CMB Meeting Minutes #180

SUBJECT: Configuration Management Board Meeting # 180 – Rev. No. 0

Contract No. 1300 Stations, Surface, Track and Systems Date 8-6-2014
 PCC No. 0014 STS
 PCC Title Traffic Signal and Streetlight Changes
 PCC Initiator Mike Acosta Dept. CM

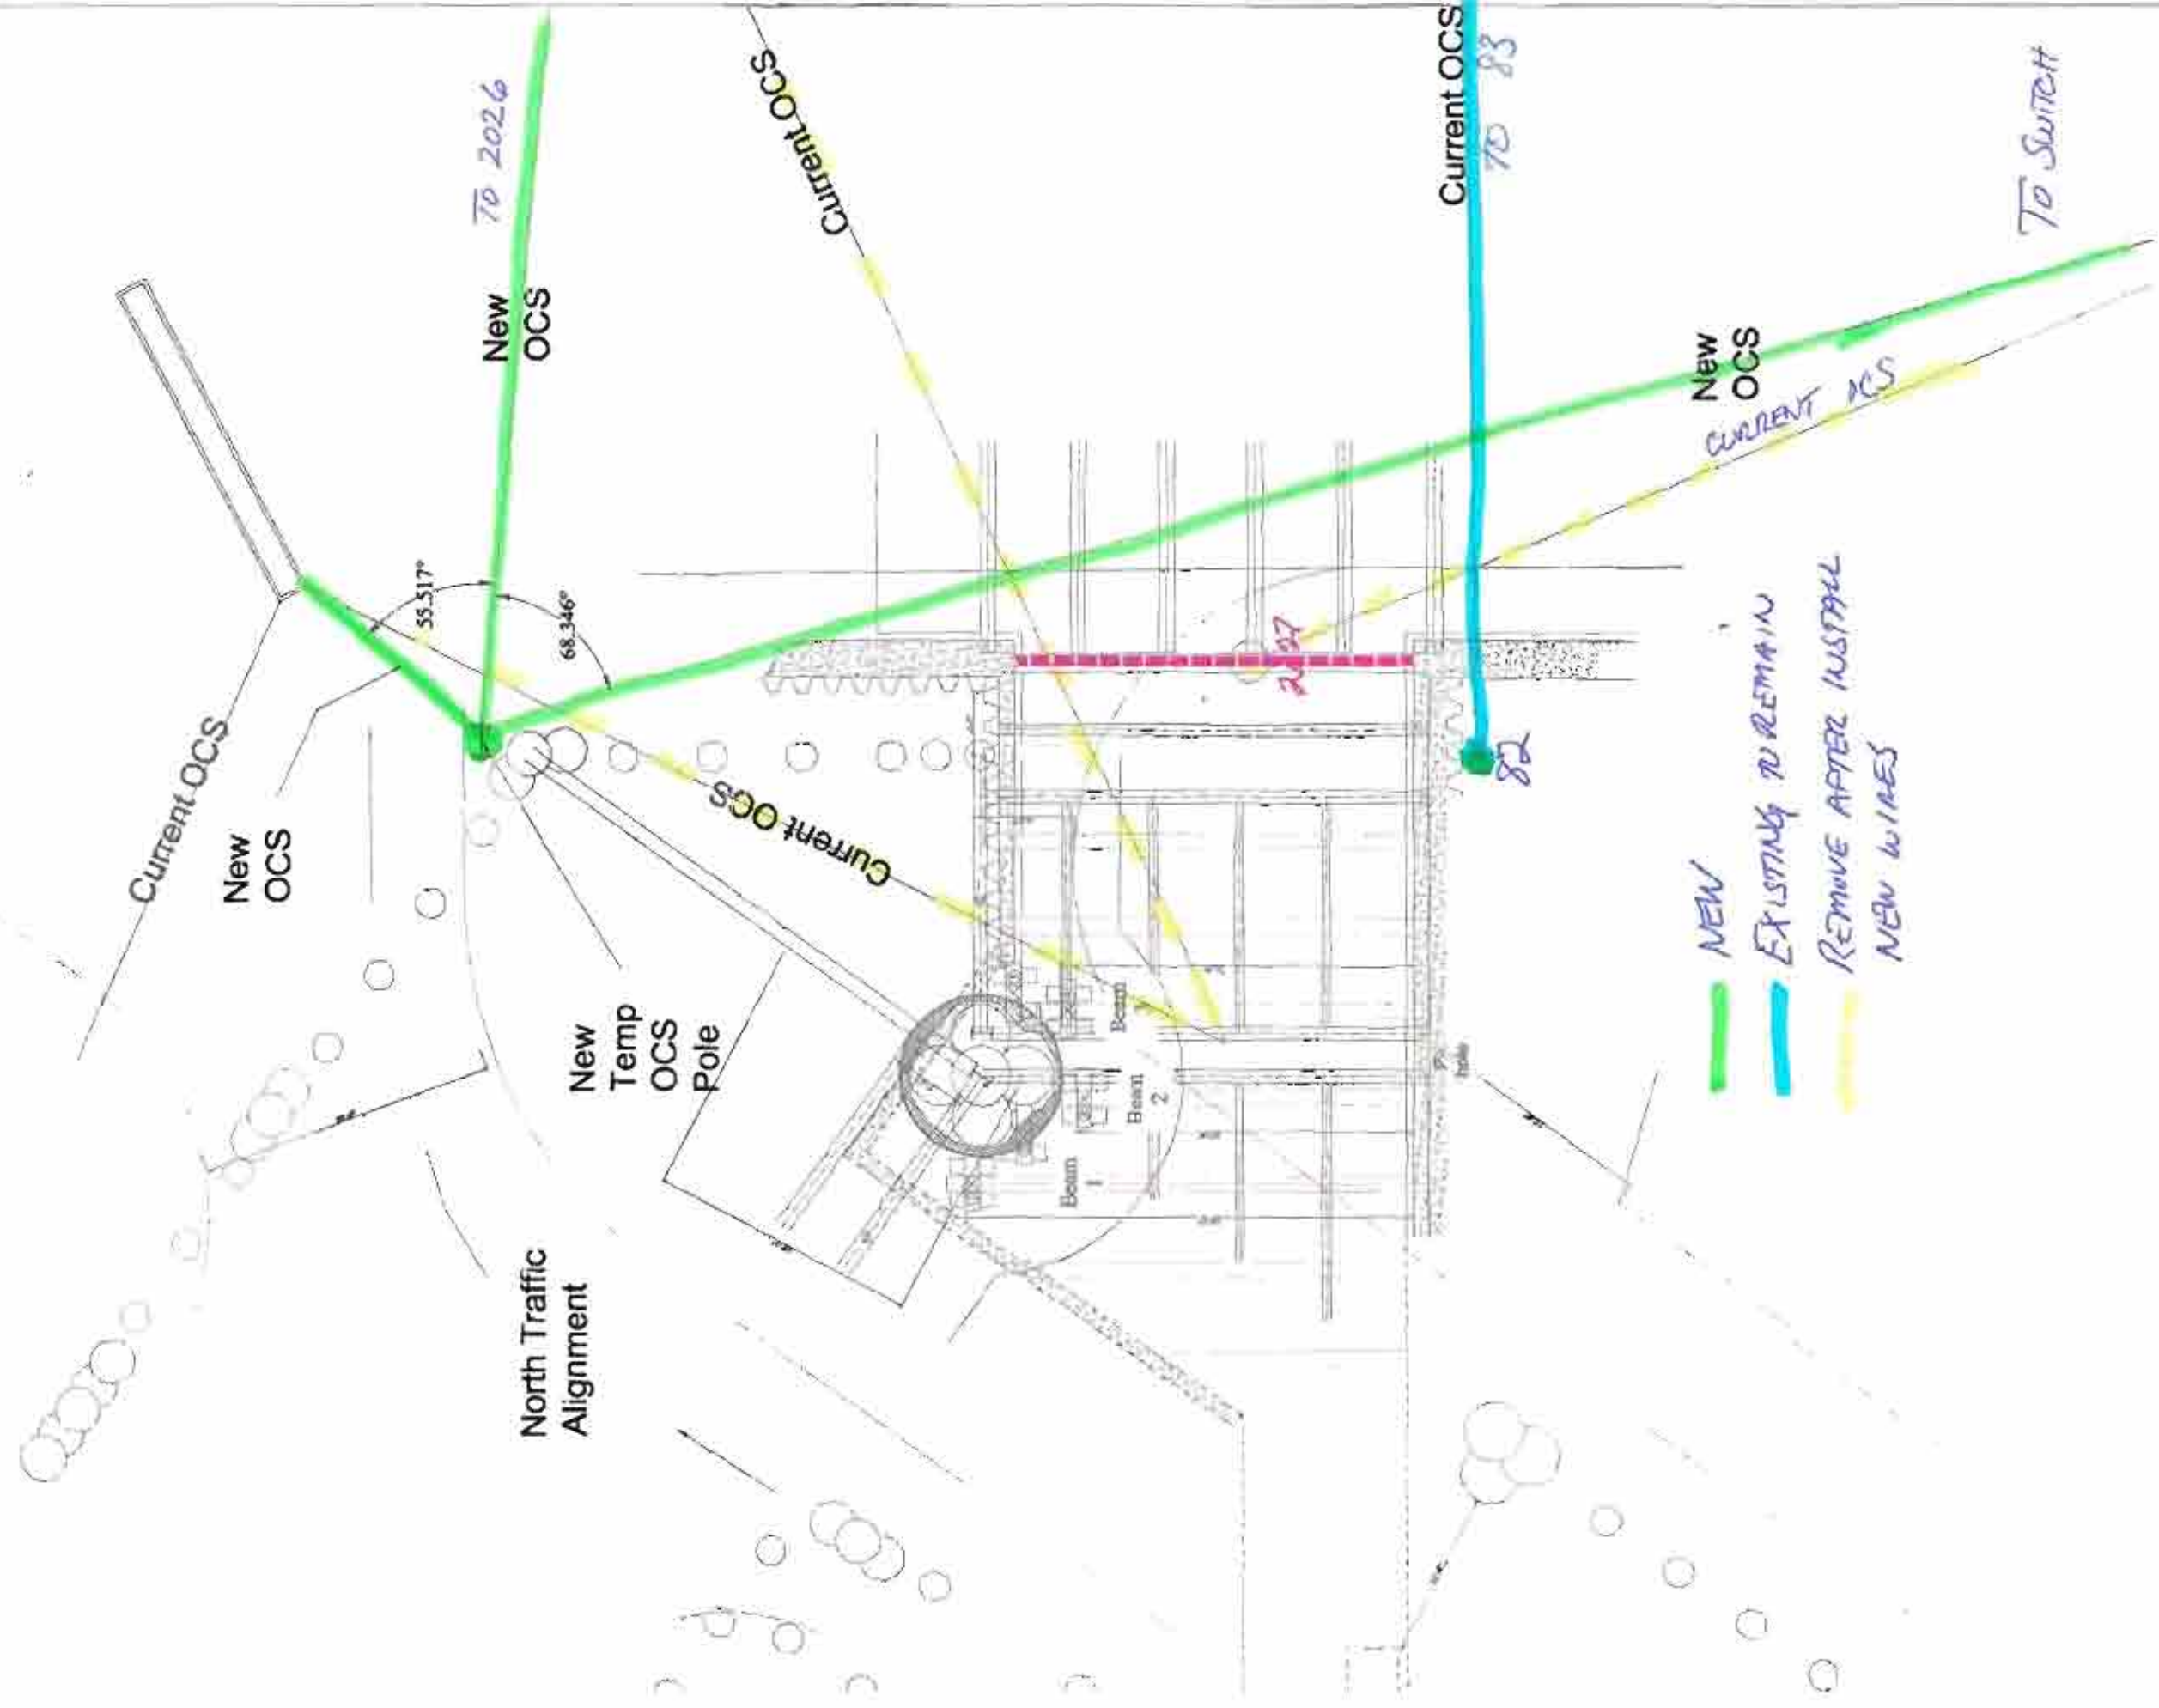
TPC has SFMTA met with TPC to review options for Phase 2 of the OCS temporary sequencing plan, as shown on OV-101. TPC maintains its stance that the temporary OCS pole, as shown on drawing OV-101, does not allow it to install the UMS station piles, excavate, and install station roof beams. SFMTA and TPC discussed various suggestions for different OCS pole and overhead line configurations.

The Contractor has already potholed the amount required to explore other areas, and additional potholing could be considered extra work. TPC is hereby directed to pothole the location, as per the attached drawing noted as "New Temp OCS Pole". Please see the attached FACO, with a not-to-exceed amount of \$2,000, directing the Contractor to proceed on force account with the pot holing.

Work under this Force Account Change Order shall not exceed \$2,000.00 without an approved supplemental Force Account Change Order. The Contractor shall notify the SFMTA promptly in writing when costs under this Force Account Change Order exceed 80% of the not-to-exceed amount.

OCS FOUNDATION

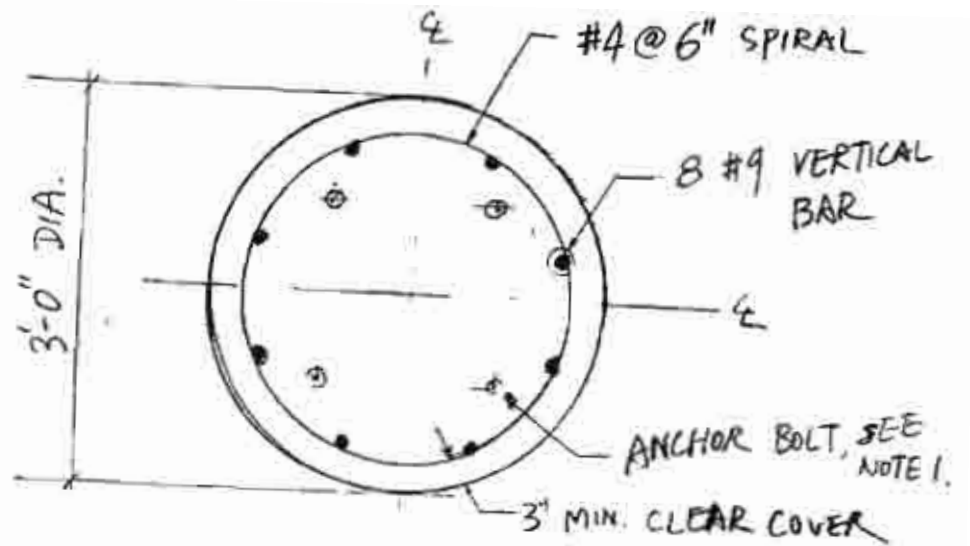
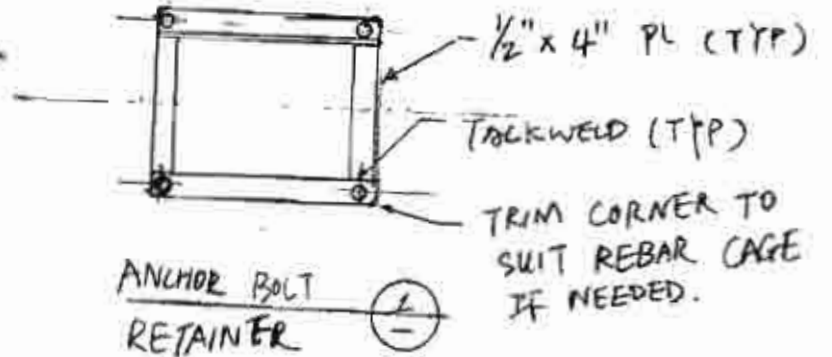
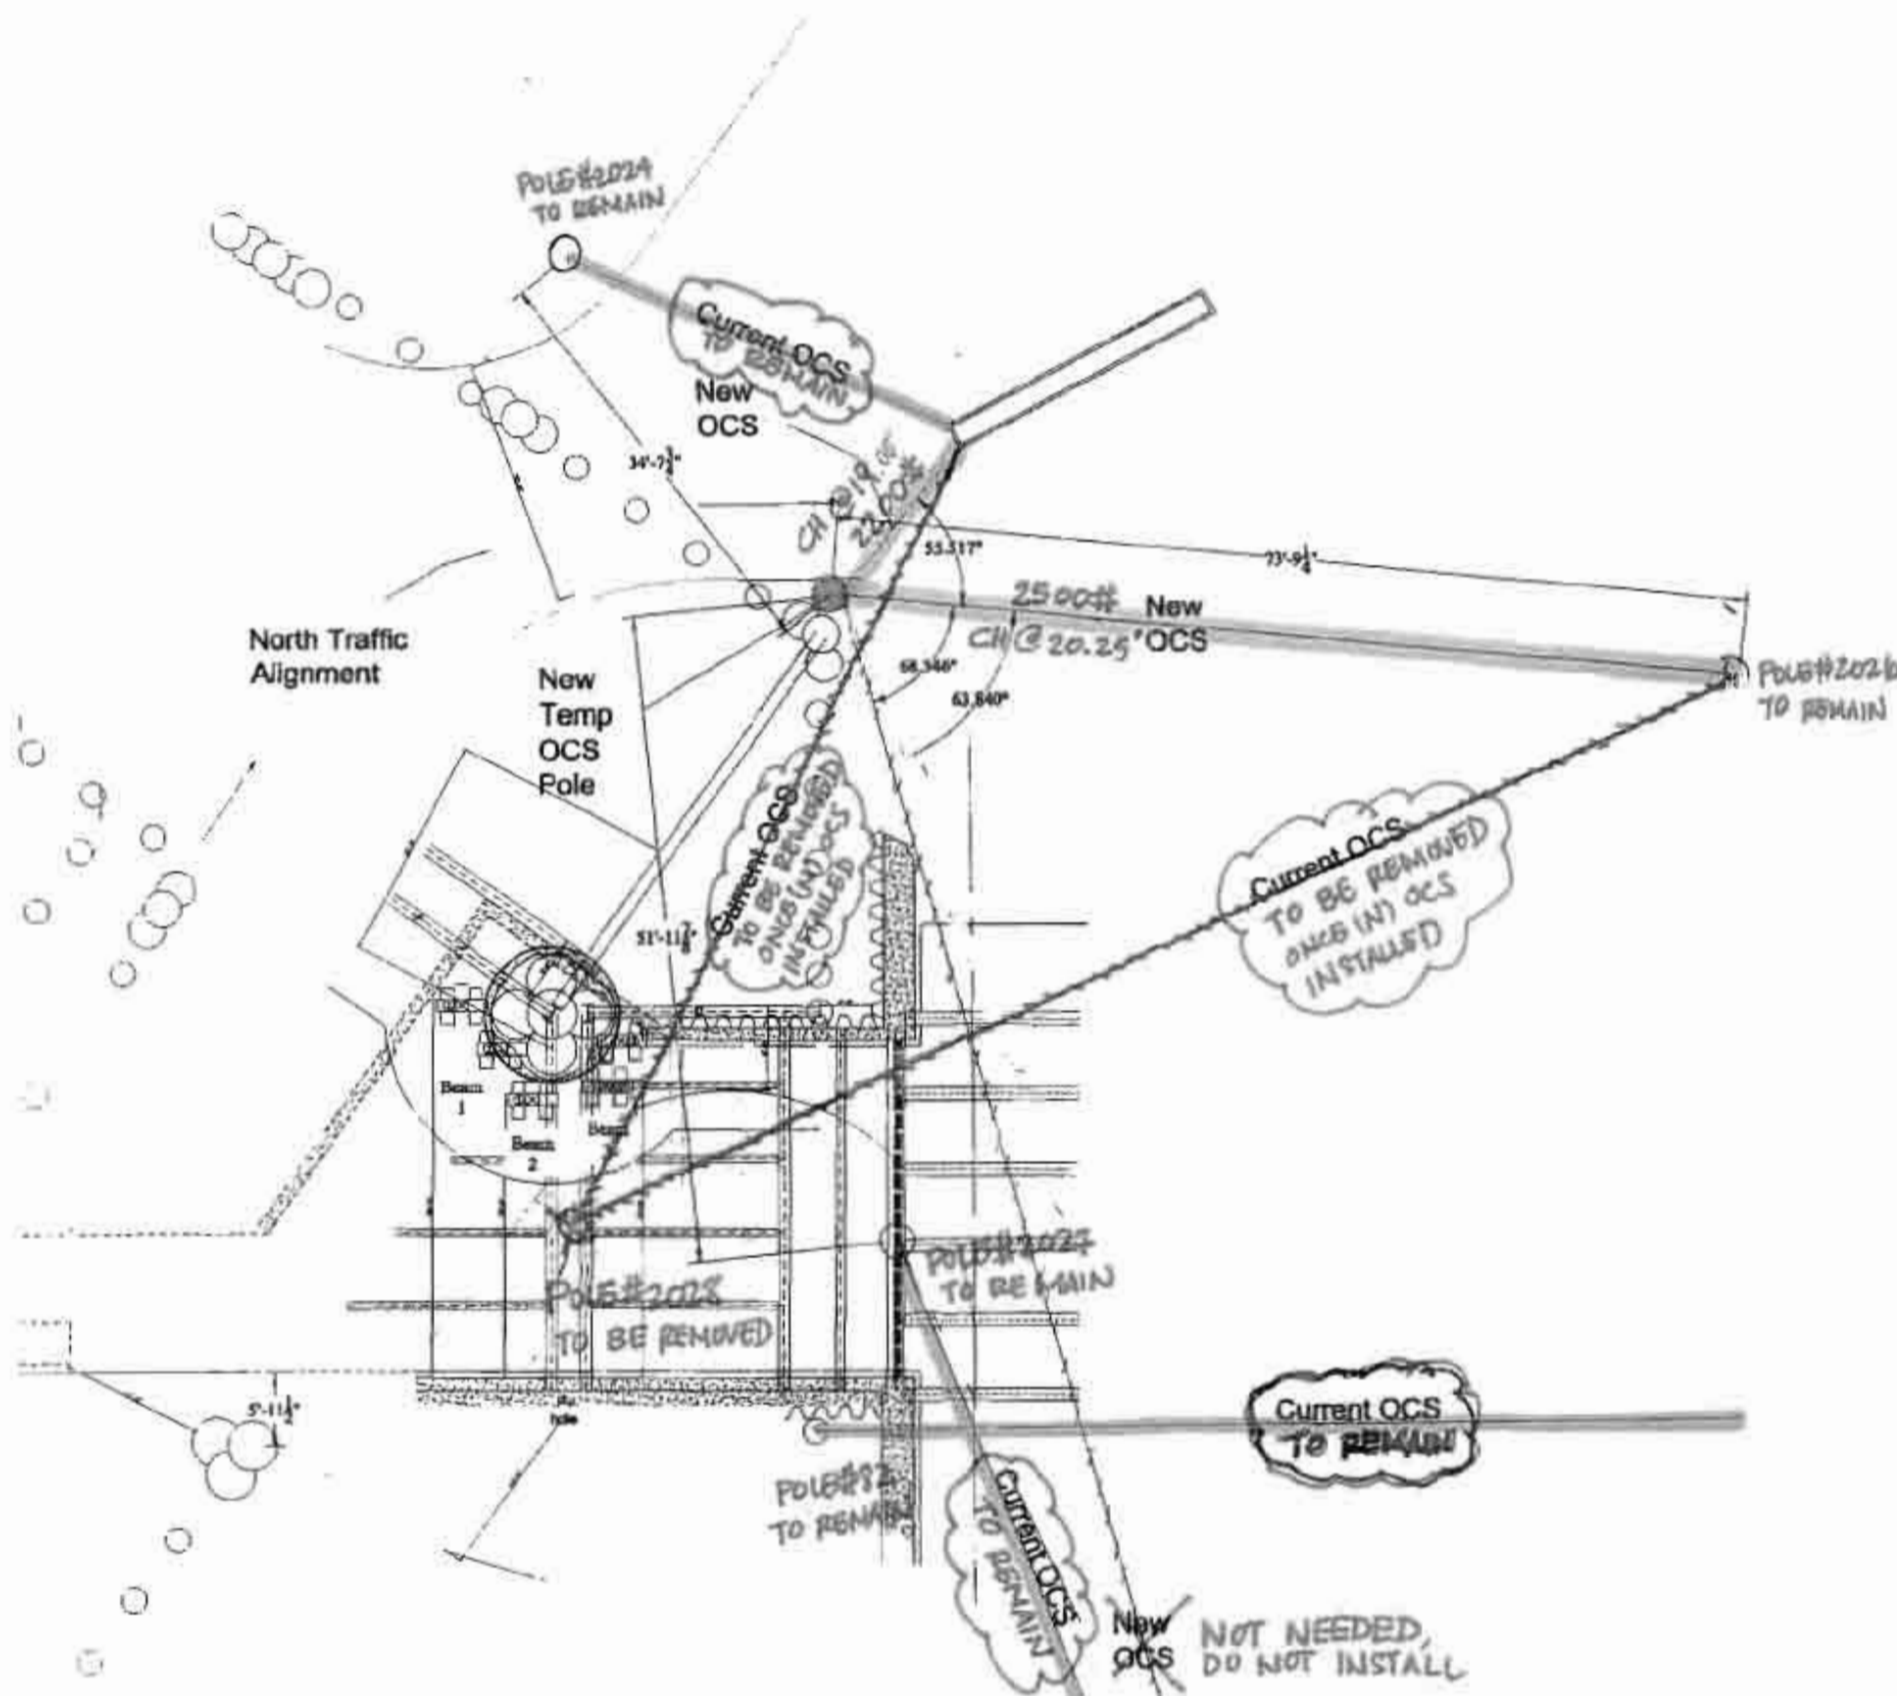
The temporary pole relocation and foundation design shall be the Contractor's responsibility. In accordance with Section 01 56 10 Temporary Site Construction, Article 1.01.B states that Contractor shall provide all temporary construction required in the execution of the Work that is not to be part of the completed facilities to be provided under this Contract. Further on Drawing ST-791, Note 6 states, "Contractor to design foundation in temporary stage. For loading see reference drawings." The reference drawing (CL-7971_Rev2) shows the loading criteria for Type 770, which is the designated pole type for Pole #2050.

1. REFER TO POLE NO. 770 OF DRAWING CL-7971 FOR INFORMATION NOT PROVIDED.

- (N) TEMP OCS POLE TYPE 770
- RESULTANT FORCE ON POLE = 4000#
- DESIGN FOUNDATION FOR STANDARD POLE CAPACITY FOR 770 TYPE, PER TABLE ON CL-7971
- MAX ALLOWABLE MOMENT = 183 K-FT

Proposed mitigation of soil lens between JT and sidewalk

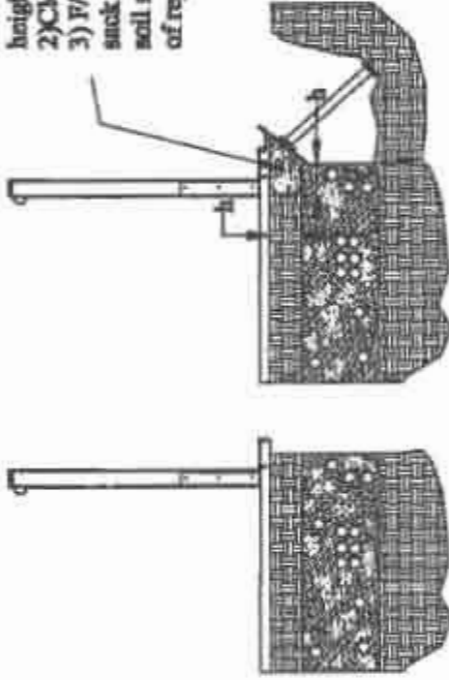
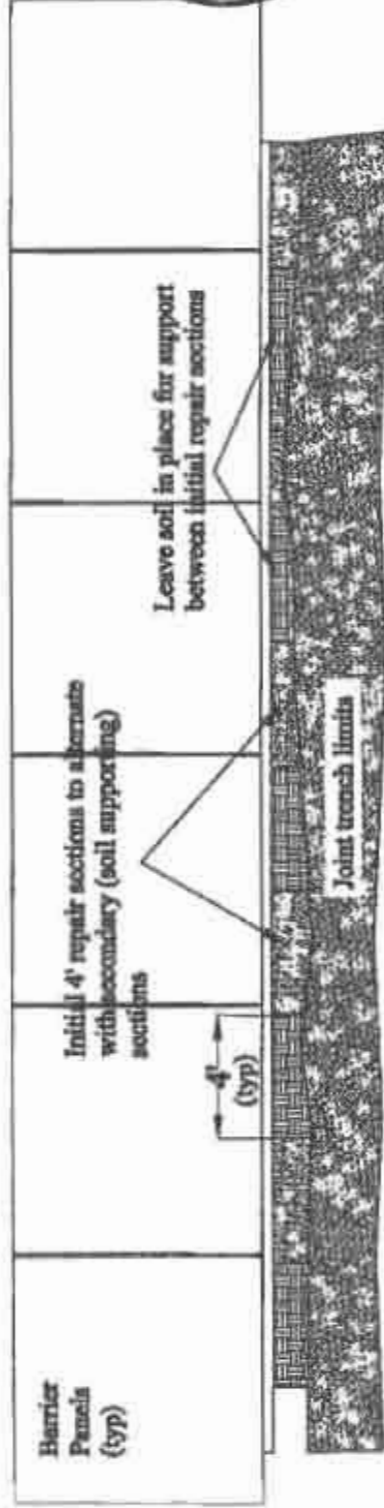
UMS ES-123 shows a utility trench on both the East and West sides of Stockton where Type B piles are to be installed. Tutor Perini relied on the dimensions provided and that the envelope of 6'-11" wide by 12' to 13' deep (both to vary) were of adequate depth to serve the purpose of standing and supporting the sidewalk and adjacent excavations without additional means since the 1251 drawings JT-322 and JT-327 show a solid homogeneous CDF backfill.

This matter is created by site conditions not being as shown on the Contract Documents. Please issue a change order and a directive that the proposed mitigation be executed forthwith.

- 1) Excavate soil lens back from face of cut equal to height in 4' max. reaches.
- 2) Clean top of JT
- 3) F/P 4' placements of 2 sack sand slurry (maintain soil support for 4' each side of repair).

Proposed mitigation of soil lens between JT and sidewalk

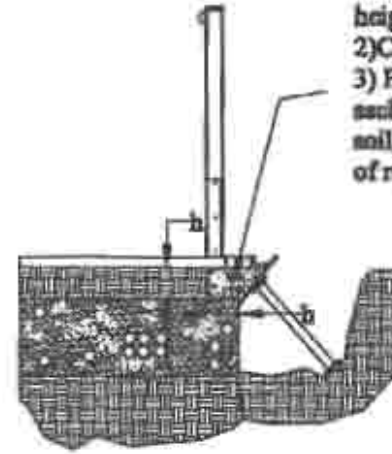
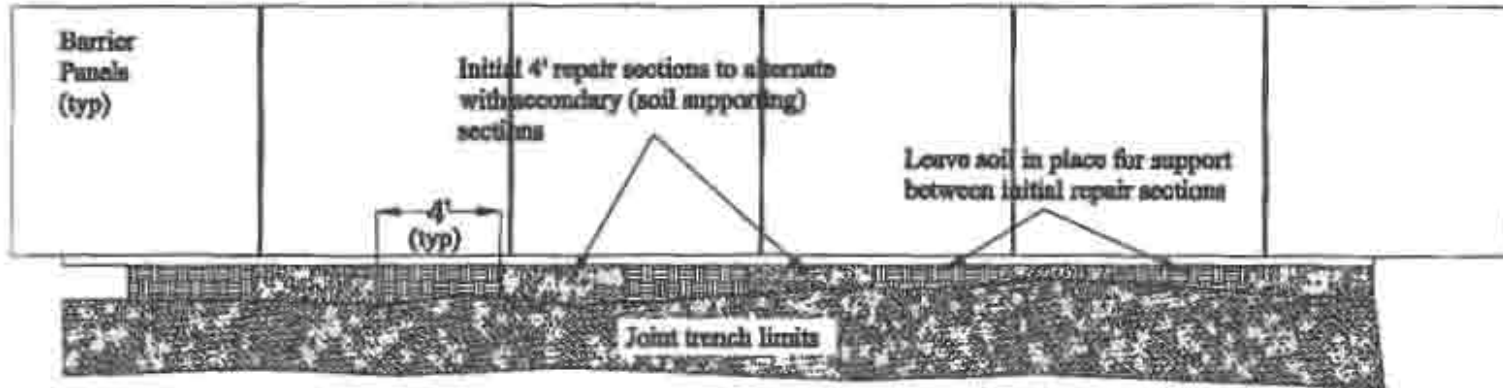
Finally, TPC appreciates the sketches provided with SFMTA's SLN 183 because the sketch confirms that the 6'-11" wide by 12' deep block of CDF as shown on UMS ES-123 has not been provided and that the block of CDF has been interrupted with layers of sand, a change made under the previous contract.

- 1) Excavate soil lens back from face of cut equal to height in 4' max. reaches.
- 2) Clean top of JT
- 3) F/P 4' placements of 2 sack sand slurry (maintain soil support for 4' each side of repair).
